**Kern Delta Water District – KDWD 22-02 – Old River Basins Grading Project**  
**RFI Responses – November 10, 2022**

**REQUEST FOR INFORMATION #7.0 (Paraphrased):**

DRAWING NO. **26** of 37

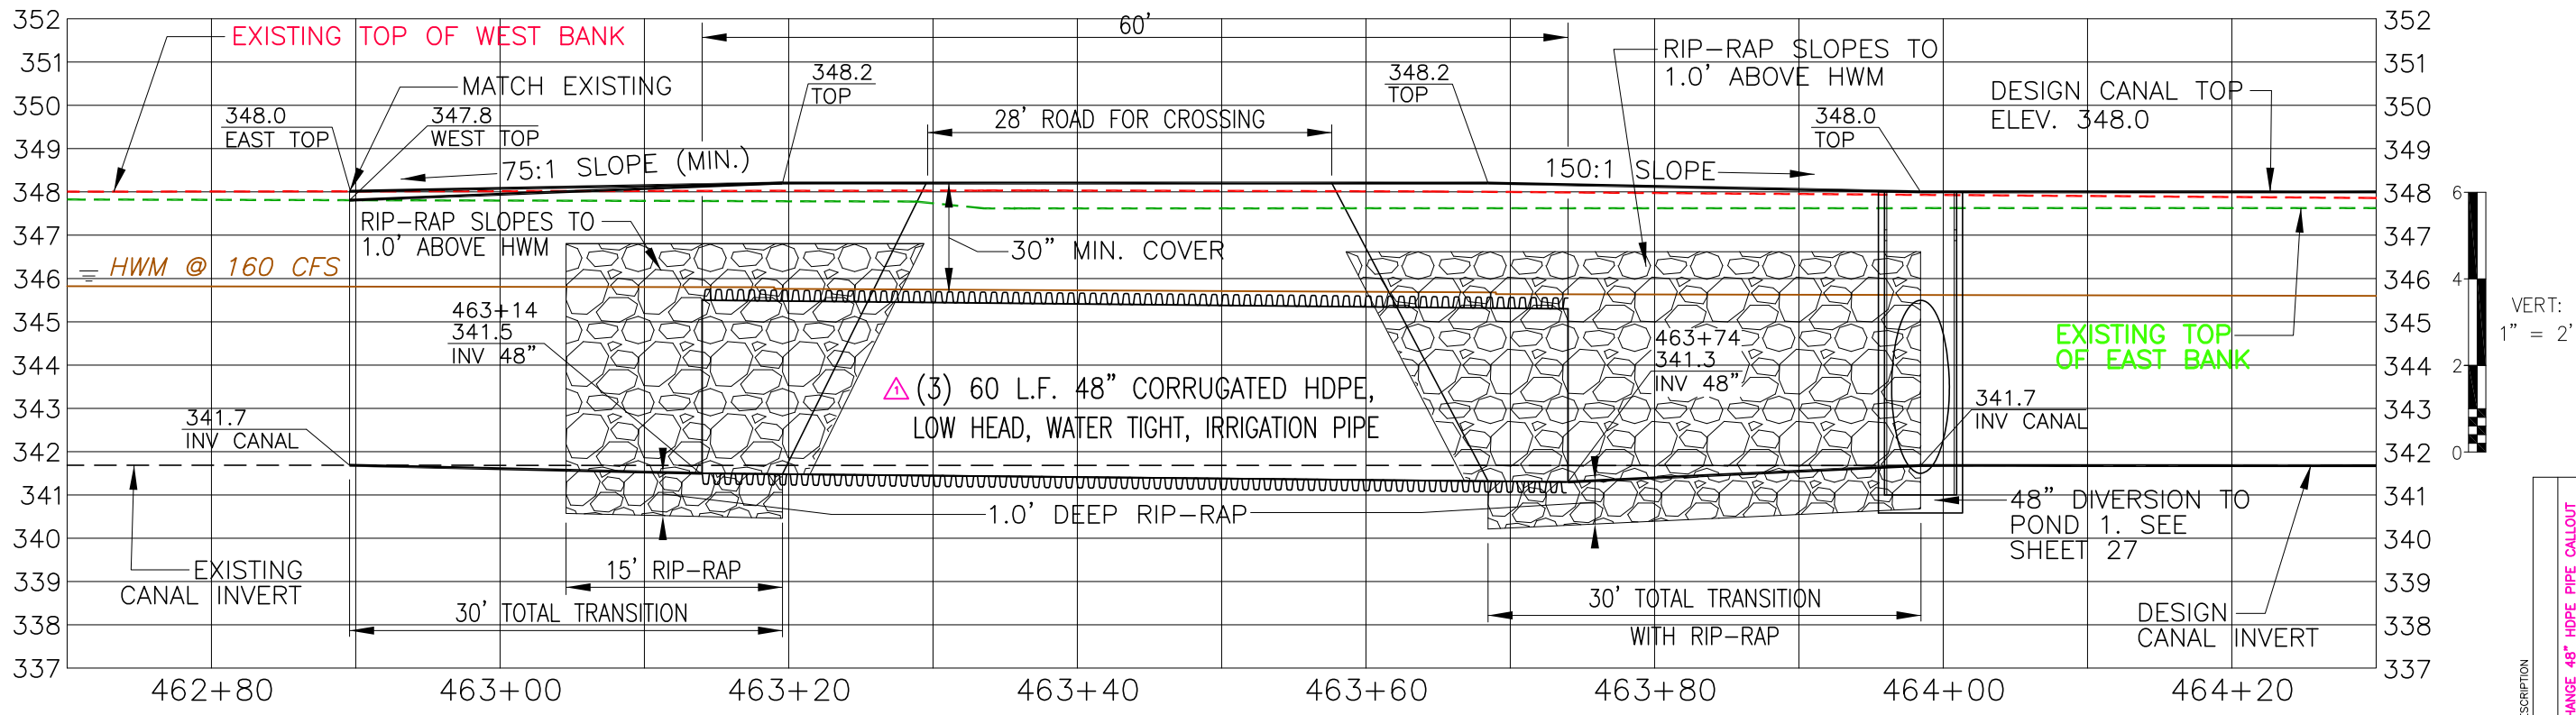
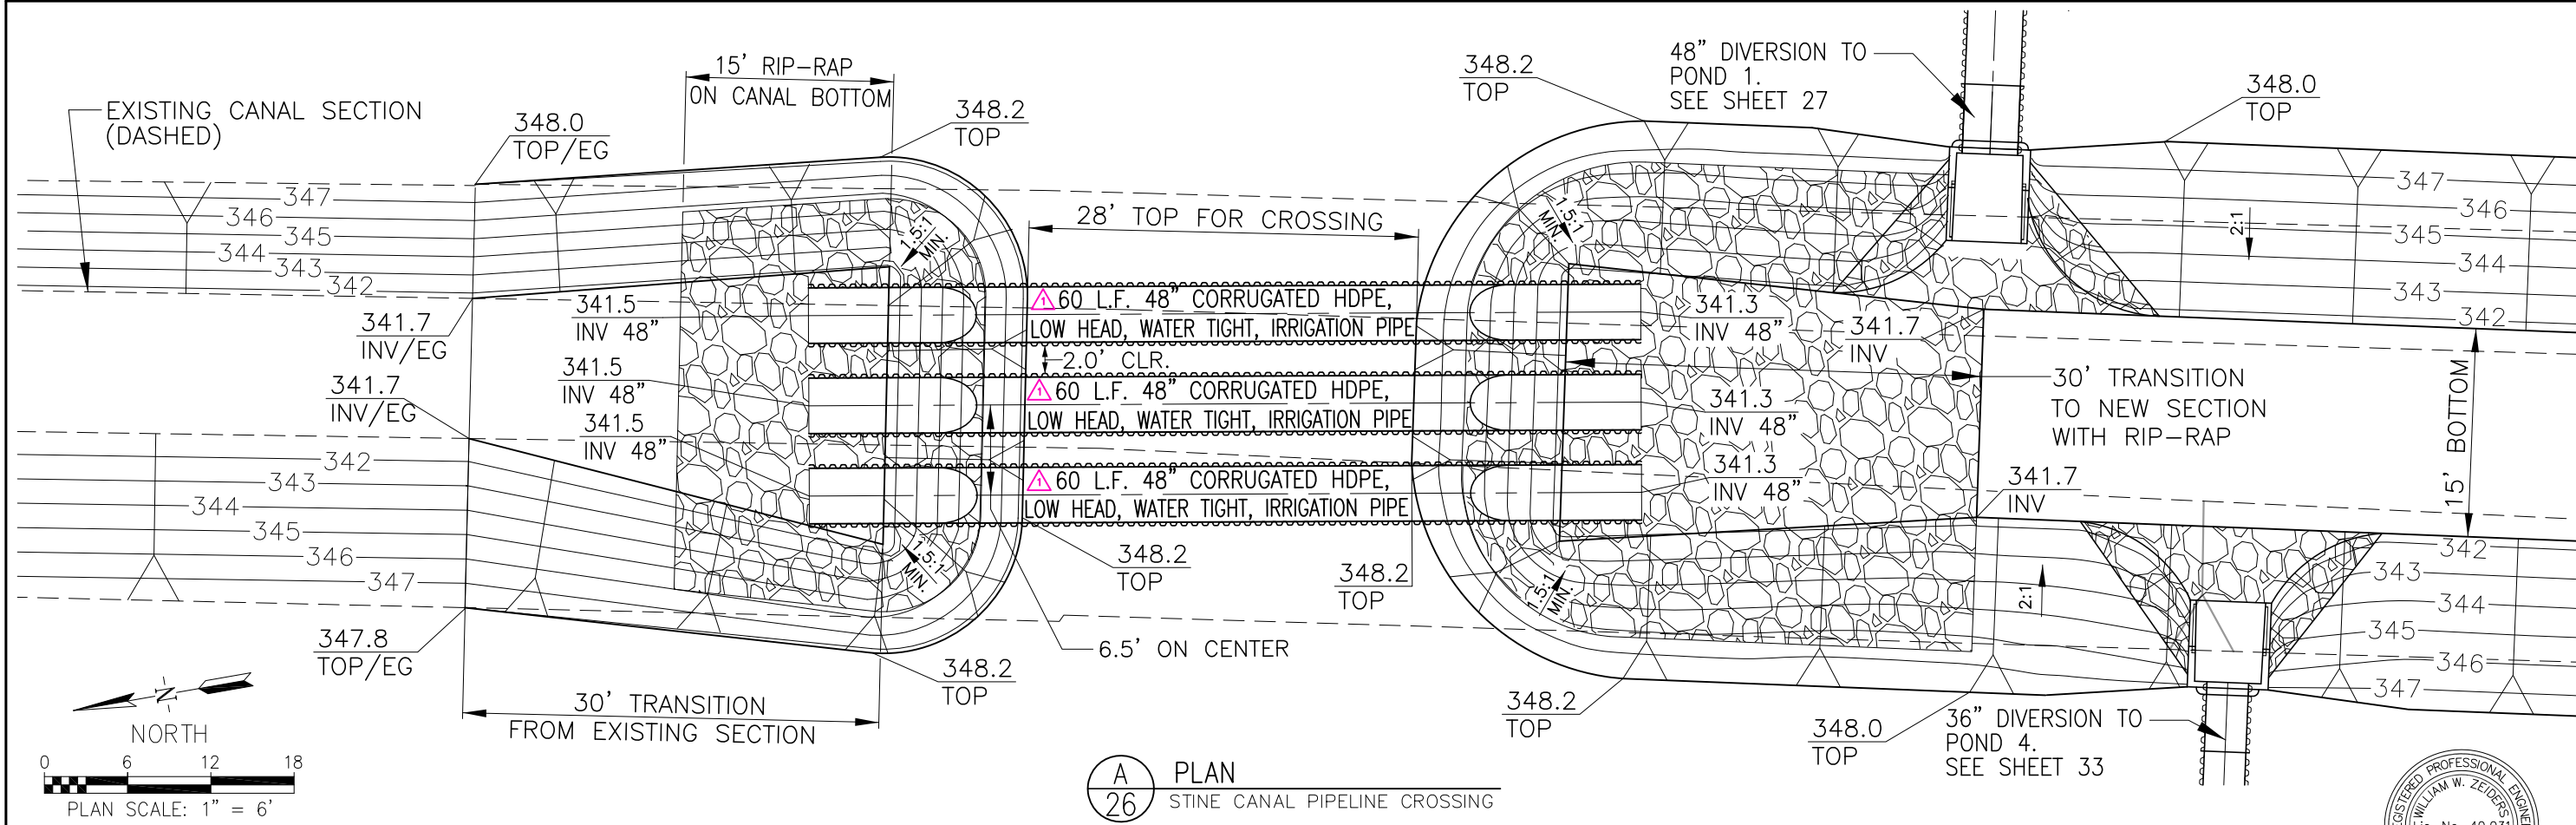
Sheet 26 of the plan set (showing the triple 48” HDPE road crossing) calls out for DR32.5 48” HDPE. Specifications section G calls for “Corrugated HDPE, Low Head, Water-Tight, Irrigation Pipe, as manufactured by ADS.” Which is correct?

All HDPE Piping purchased for this project shall be Corrugated HDPE, Low Head, Water-Tight, Irrigation Pipe, as manufactured by ADS. A revision to sheet 26 of the plan set has been issued to clarify this, and is attached to this RFI response.

REV.	DATE	DESCRIPTION
1	11/09/22	CHANGE 48" HDPE PIPE CALLOUT
